Submission 728 (DeLu Ventures, April 18, 2020)

Bakersfield - Palmdale - RECORD #728 DETAIL

Response to Submission 728 (DeLu Ventures, April 18, 2020)

Figure 4-9 Example of Local Permeability Analysis for Project Permeability with “Null” Data for At-Grade Segments

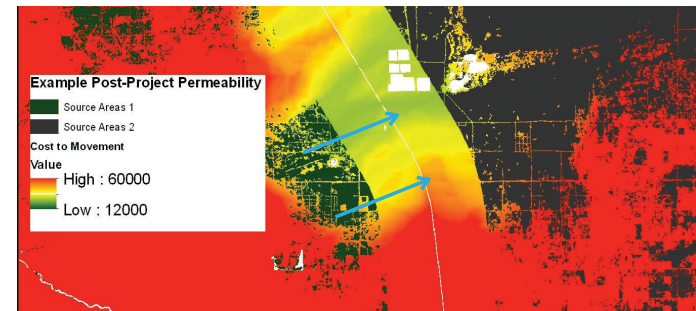
There are serious issues and limitations with the “local permeability analysis” that drastically reduce its utility of generating useful information to evaluate impacts on wildlife movement. The “local permeability analyses” considered only the linear feature of the HSR centerline as a movement barrier. It did not factor in the Actual Project Footprint, Permanent Impacts, or Temporary Impacts. See **Figure 4-9 Example of Local Permeability Analysis for Project Permeability with “Null” Data for At-Grade Segments**. As can be seen in Figure 4-9, the at-grade segments were represented by “Null” data that was one pixel wide, or 30 meters (98 feet) squared. In addition, the “moving average window calculated the average value for all pixels within a 90-meter (295-foot) radius. This 90-meter radius pixel value was collected every 50 meters (164 feet) along the HSR alignment. The moving window average was calculated for existing conditions, project, and project with wildlife crossings scenarios for each focal species.” The values of the 90-meter radius pixel values would have been drastically different had the actual project footprint/permanent impacts been used in the analyses, instead of the linear HSR centerline. If the Actual Project Footprint and Permanent Impacts had been factored into the model the results of the analyses summarized in Table 6-7 of the WCA would have been significantly different. Basically, all of their calculations about “improvements” with the wildlife crossings don’t accurately reflect the real world. Wildlife and regulatory agencies should have very low confidence in the results of the “local permeability analyses”, and therefore on the NEPA and CEQA determinations with respect to wildlife movement, as the determinations are almost entirely based on the “local permeability analyses”.

Habitat fragmentation was analyzed in the WCA and summarized in Impact BIO#5 in Section 3.7.6.4 of this Final EIR/EIS. Section 6.3.2 of the WCA analyzes impacts to core and patch habitat and Table 6-6 of the WCA lists the lengths of suitable core and patch habitat within the HSR centerline. Figures 6-1 through 6-9 show underground tunnel sections and elevated viaduct sections in relation to core and patch habitat for each of the 9 focal species (mountain lion, mule deer, American badger, blunt-nosed leopard lizard, desert kit fox, desert tortoise, San Joaquin kit fox, Tipton kangaroo rat, and western gray squirrel) to cross the HSR alignment between core and patch habitat. As discussed in Impact BIO#5 in Section 3.7.6.4 of this Final EIR/EIS, construction of the HSR project could result in habitat fragmentation, habitat shifts, increased foraging competition, or limitations on genetic exchange. However, the construction of tunnels and viaducts, particularly in the mountainous areas, would allow for continued wildlife movement over and under the HSR alignment. Additionally, wildlife undercrossings and overcrossings would be installed along the length of the alignment. The 39 wildlife crossings would be designed to provide additional crossing opportunities where at-grade sections are longer in length. As concluded in Impact BIO#5, the design characteristics of the project include effective IAMFs to identify wildlife crossings and delineate Environmentally Sensitive Areas or environmentally restricted areas on final construction plans and in the field (BIO-IAMF#8 and BIO-IAMF#5). In addition to the IAMFs, mitigation measures were identified to reduce impacts on wildlife crossings and habitat linkages to a less than significant level by avoidance, protection, or restoration methods. These measures include: BIO-MM#42, BIO-MM#37, BIO-MM#56, BIO-MM#64, BIO-MM#77, and BIO-MM#78, which would allow for the protection of habitat linkages. These measures would work together with design features to minimize or avoid impacts on wildlife crossings during construction activities so as not to interfere substantially with the movement of native wildlife species.
